TVA-SQN-TS-06-03

**SEQUOYAH NUCLEAR PLANT (SQN) - UNITS 1 AND 2 - RESPONSE TO
REQUEST FOR ADDITIONAL INFORMATION (RAI) FOR TECHNICAL
SPECIFICATIONS (TS) CHANGE 06-03 (TAC NOS. MD2621 AND MD2622)**

Response to Request for Additional Information

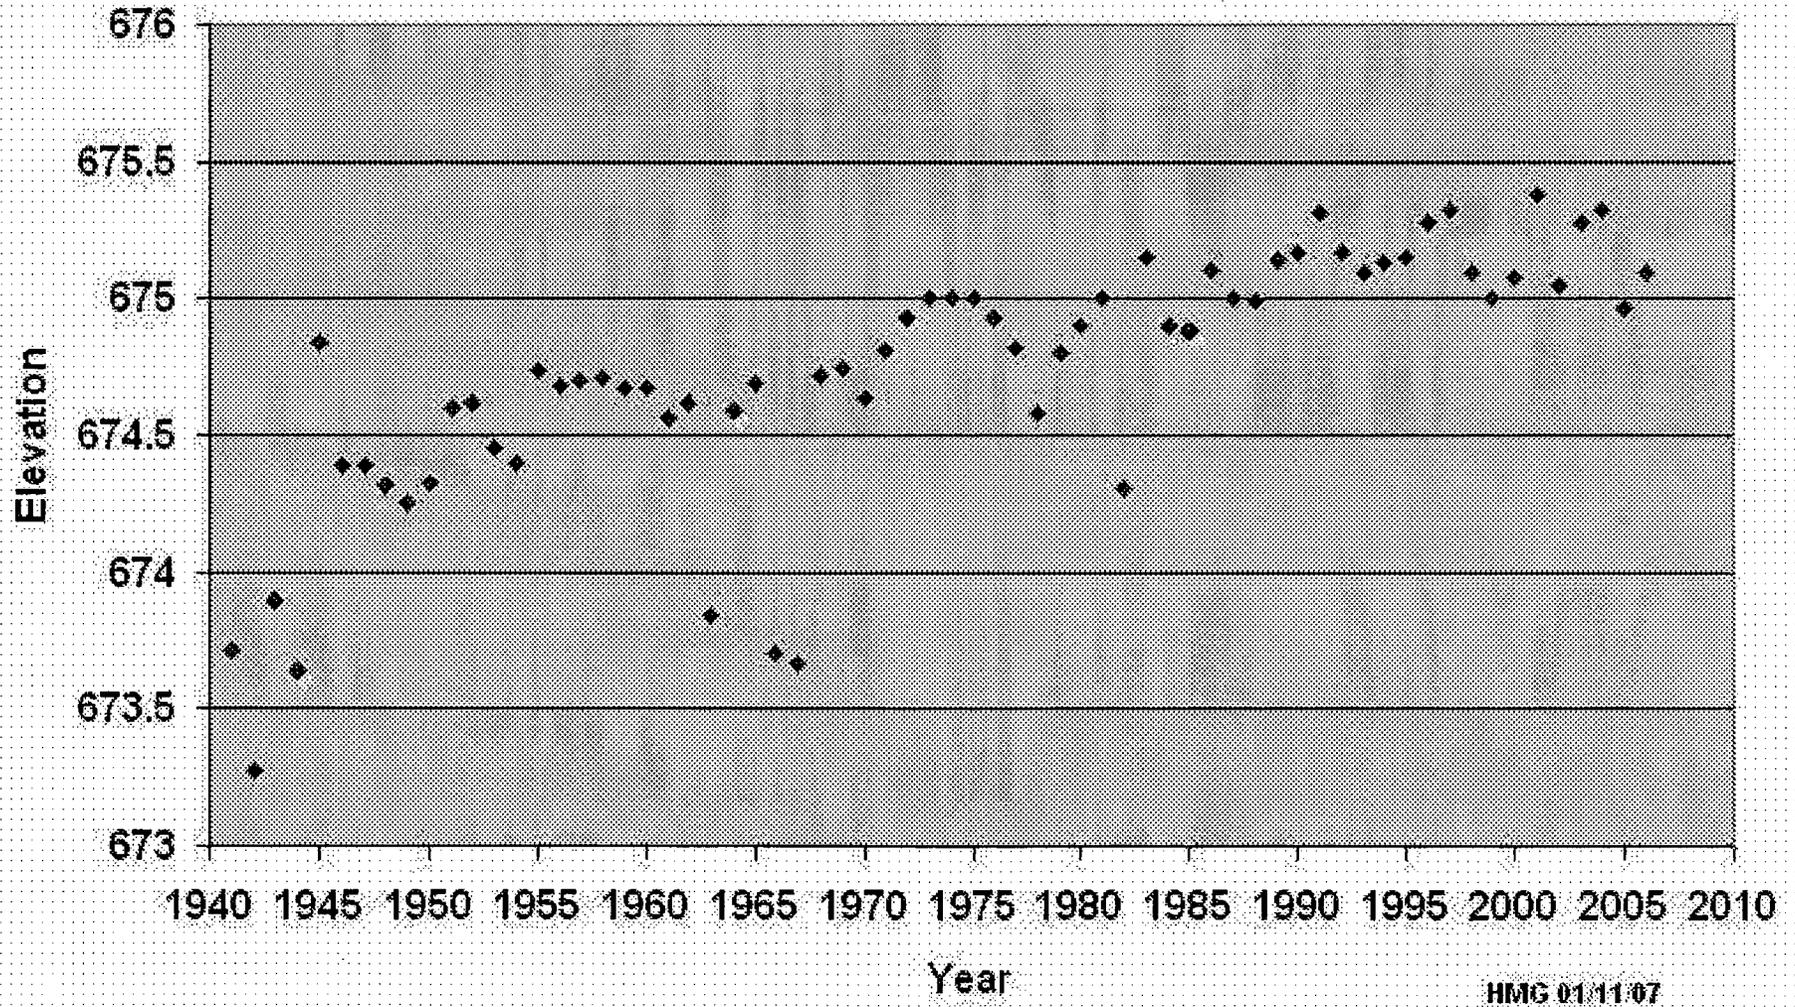
"Please clarify the condition of simulation for the recession curve in Page 18 of Reference #8."

The physical configurations of the runs are described at the top of the page and in the legend. However, there are two axes. The red curves are for Chickamauga discharges, as shown on the right y axis. The blue curves are for SQN river elevations as shown on the left y axis. Data are plotted at one hour intervals.

As expected, the water level recession at SQN is more rapid for the 1000-foot breach width as compared to the 300-foot breach width. Both reach essentially the same steady state elevation approximately 60 hours after dam failure. The Chickamauga discharge peaks at about 466,000 cfs for the 300-foot breach, and at about 941,000 cfs for the 1000-foot width within the first hour (peaks are not shown because they occur before the end of the first hour). This relationship of peak discharges is not linear as a function of breach width due to submergence effects from the downstream reservoir, Nickajack.

Chickamauga HW Duration Curve 1986-2005

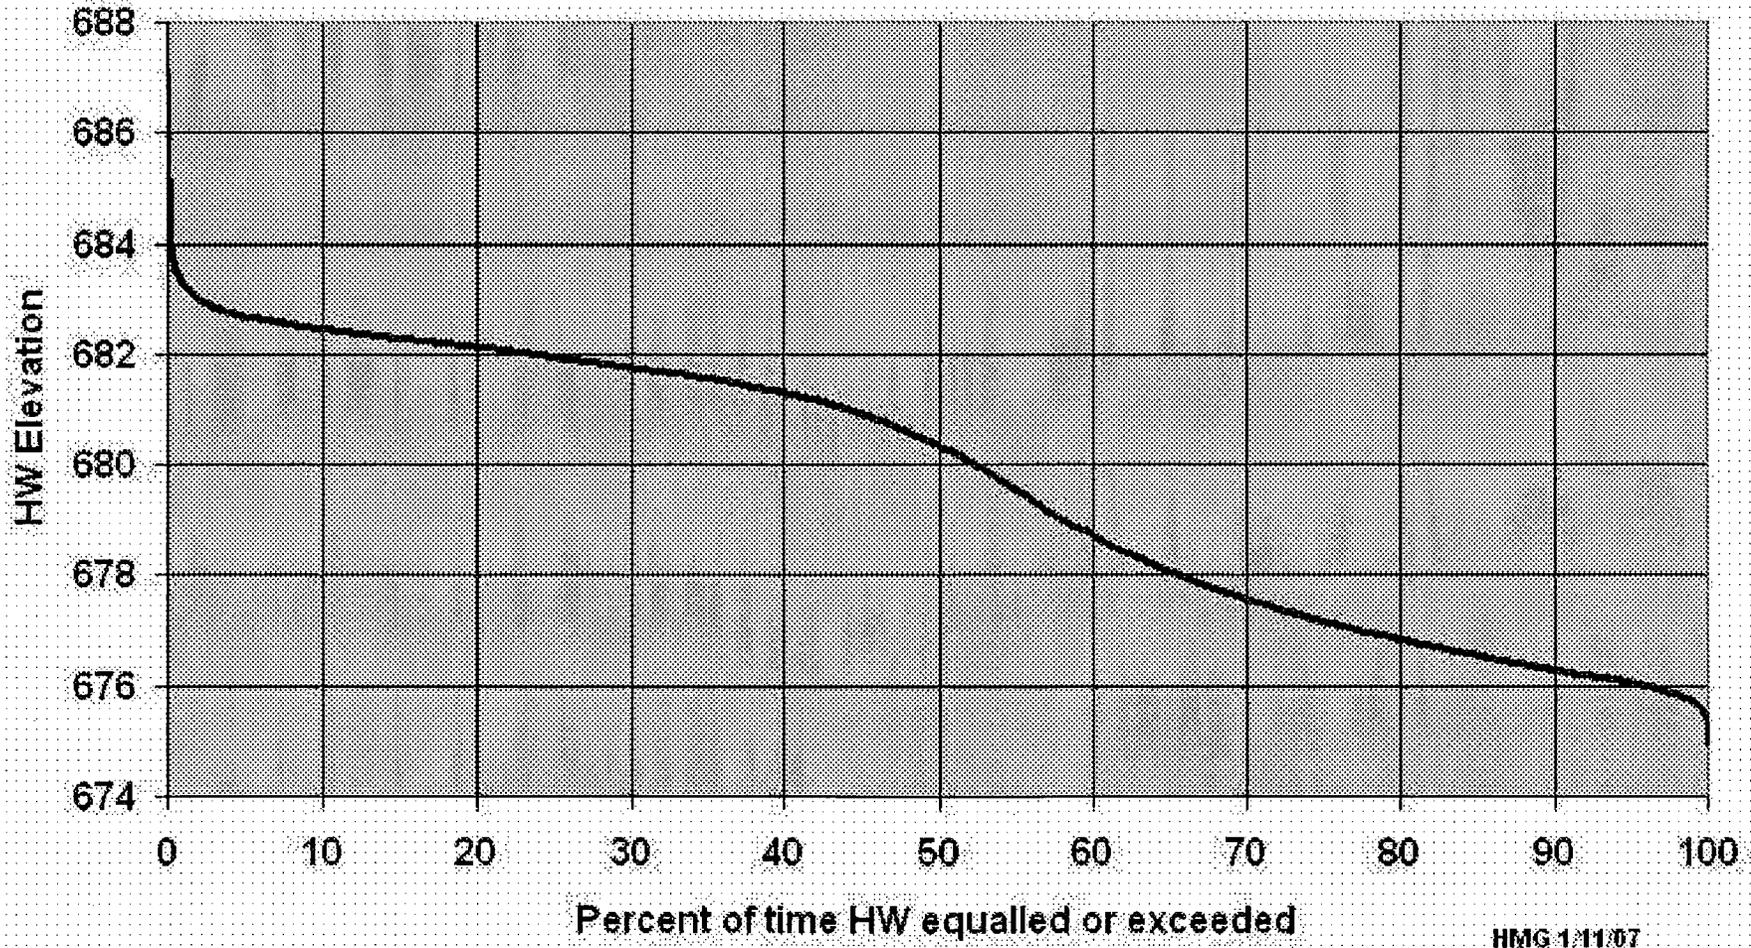
"While the initial pool level of the Chickamauga reservoir is very sensitive to the rate of reservoir recession, the applicant should justify the use of an initial pool level of 680 feet in simulating reservoir recession curves. Or, please explain why one of driest/wettest water levels should not be used as an initial condition to be conservative."

As discussed and presented in response to Question 2, some sensitivities were performed using different hardwater elevations. Elevation 681 is a representative median elevation for the previous 20 years.

Conservatism for this submittal was built in by only counting the hours during the recession from elevation 674 to 670. Run C, as shown in response to Question 2, does address the issue of starting at an extreme elevation, in this case elevation 675. This pool elevation is exceeded 99.9 percent of the time in actual operations (see Attachment B). For this case, with a 400-foot breach width, instantaneous failure, and only counting hours from 674 to 670 feet, the results indicate an elapsed time of 4.18 hours. The total elapsed time from failure (675 - 670) is 5.62 hours.
